Informal document No. **GRE-56-8**
(56th GRE, 4-7 April 2006
agenda item 12.)

PROPOSAL FOR DRAFT AMENDMENTS TO REGULATION No. 98

(Headlamps with gas-discharge light sources)

Transmitted by the expert from the Working Party "Brussels 1952" (GTB)

Figure 1

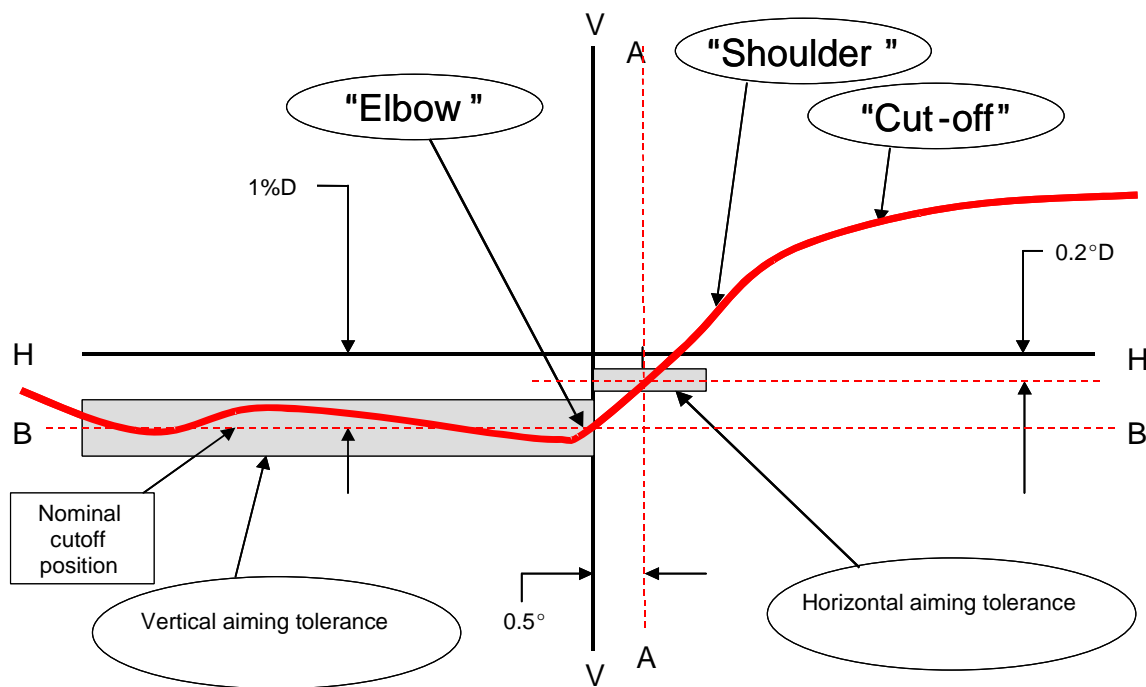
"6.2.1. **The luminous intensity distribution of the passing beam headlamp shall incorporate a "cut-off" (see Figure 1 below), which enables the headlamp to be**

- (a) For right hand traffic beams:
 - (i) a straight "horizontal part" towards the left;
 - (ii) a raised "elbow - shoulder" part towards the right.
- (b) For left hand traffic beams:
 - (i) a straight "horizontal part" towards the right;
 - (i) a raised "elbow – shoulder" part towards the left.

In each case the "elbow – shoulder" part shall have a sharp edge.

6.2.2. The headlamp shall be visually aimed by means of the "cut-off" (see Figure 1 below) as follows:

6.2.2.1. for vertical adjustment: the horizontal part of the "cut-off" is moved upward from below line B and adjusted to its nominal position one per cent (25 cm) below the H-H line;

6.2.2.2. for horizontal adjustment: the "elbow-shoulder" part of the "cut-off" shall be moved:

- for right hand traffic from right to left and shall be horizontally positioned after its movement so that:
- above the line 0.2° D its "shoulder" shall not exceed the line A to the left and
- on the the line 0.2° D or below its "shoulder" should cross the line A and
- the kink of "elbow" should be primarily on the V-V line;

Figure 1: Measurement of "cut-off" quality

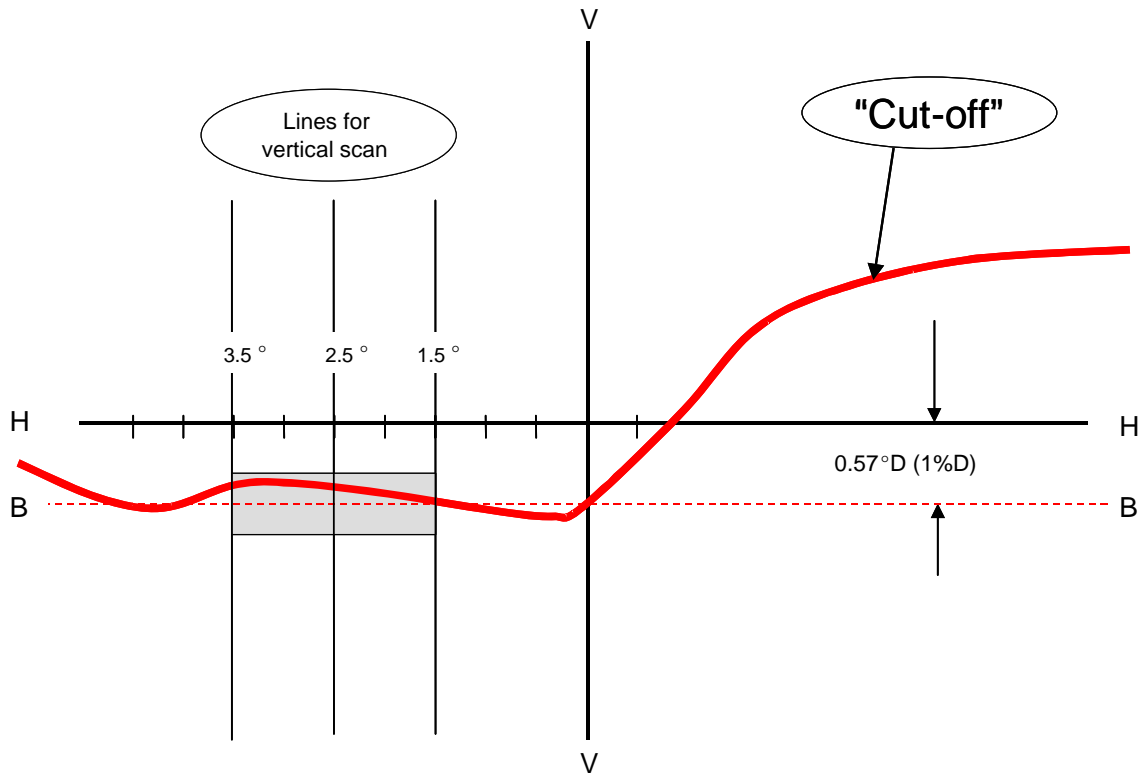
The part of the horizontal "cut-off" that serves for vertical adjustment shall be horizontal between 1.5° and 3.5° from the V-V line (see Figure 1 below).

- The inflection points of the "cut-off" gradient at the vertical lines at 1.5°, 2.5° and 3.5° shall be determined by the equation:

$$(d^2 (\log E) / d\beta^2 = 0).$$

- The maximum vertical distance between the inflection points determined shall not exceed 0.2 °.

Figure 2: Instrumental vertical and horizontal adjustment- horizontal line scan method

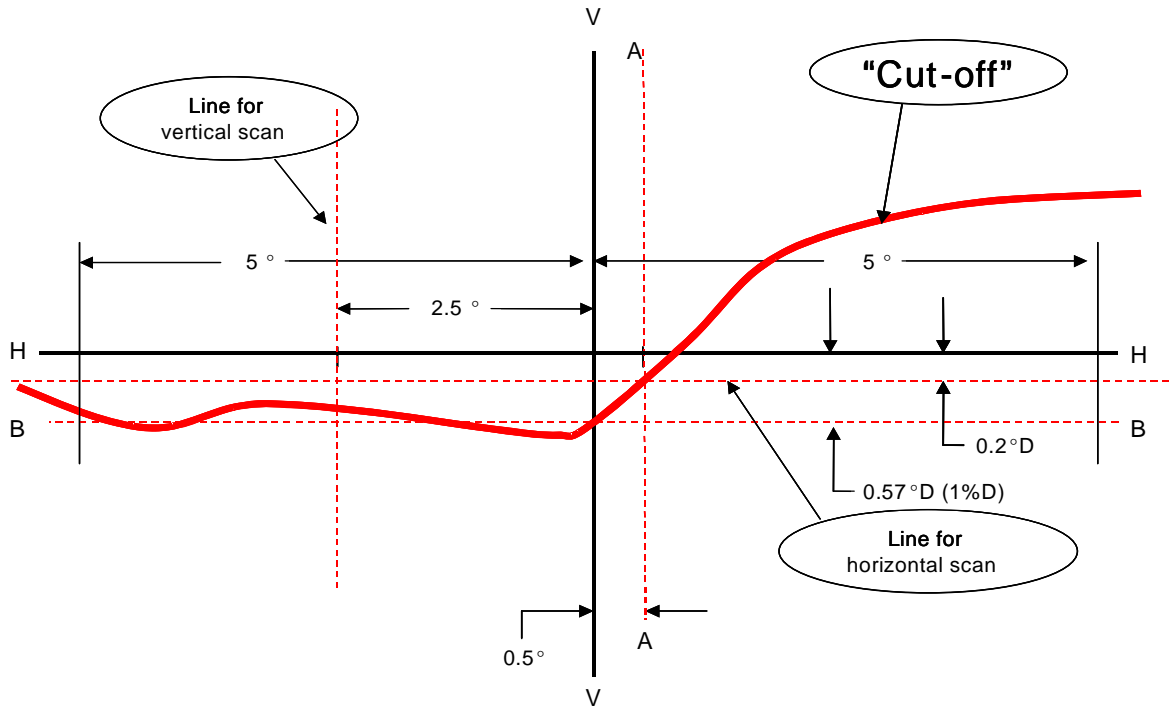
Moving upward from below the line B (see Figure 2 below), a vertical scan is carried out through the horizontal part of the "cut-off" at 2.5° from V-V. The inflection point (where $d^2 (\log E) / dv^2 = 0$) is determined and positioned on the line B situated one per cent below H-H.

(a) The "0.2 D line" method (see Figure 2 below).

A single horizontal line at 0.2° D shall be scanned from 5° left to 5° right after the lamp has been aimed vertically. The maximum gradient "G" determined using the formula $G = (\log E_{\beta} - \log E_{(\beta+0.1^{\circ})})$ where β is the horizontal position in degrees, shall not be less than 0.08.

The inflection point found on the 0.2 D line shall be positioned on the line A.

Figure 3: Instrumental vertical and horizontal adjustment-three line scan method

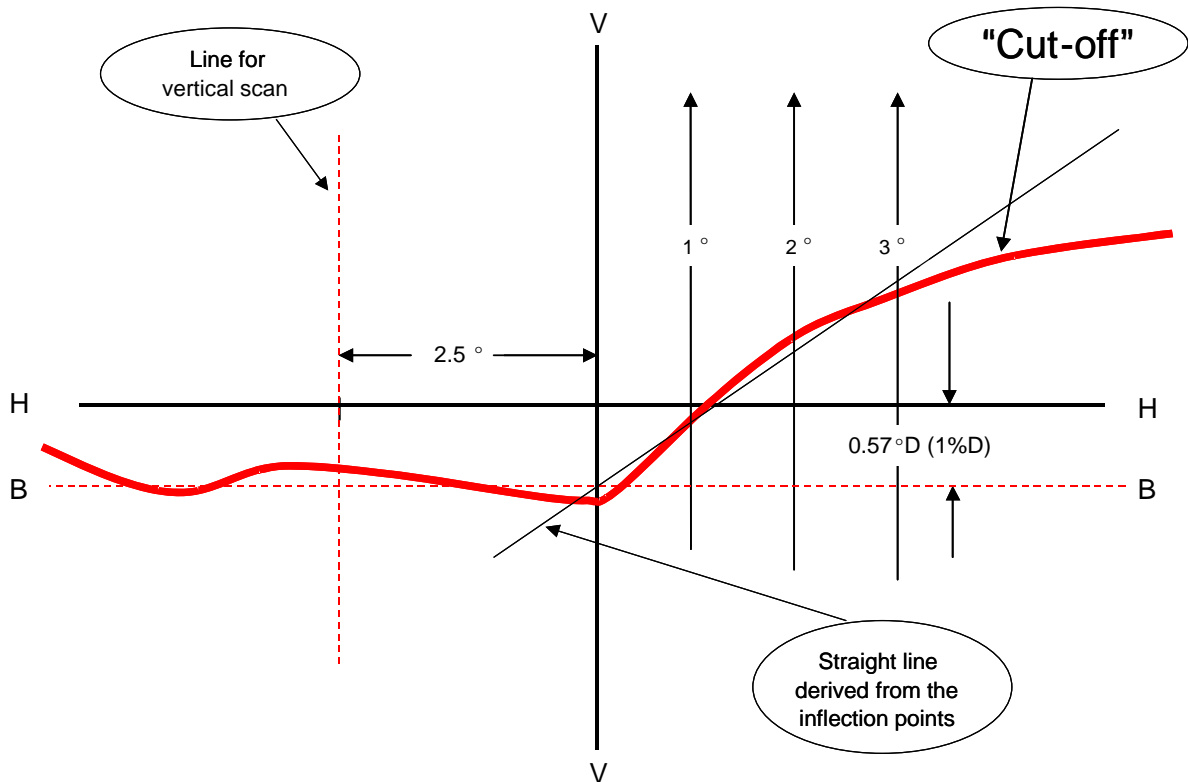
(b) The "3 line" method (see Figure 3 below)

Three vertical lines shall be scanned from 2° D to 2° U at 1°R, 2°R, and 3°R after the lamp has been aimed vertically. The respective maximum gradients "G" determined using the formula:

where β is the vertical position in degrees, shall not be less than 0.08. The inflection points found on the three lines shall be used to derive a straight line. The intersection of this line and the line B found while performing vertical aim shall be placed on the V line.
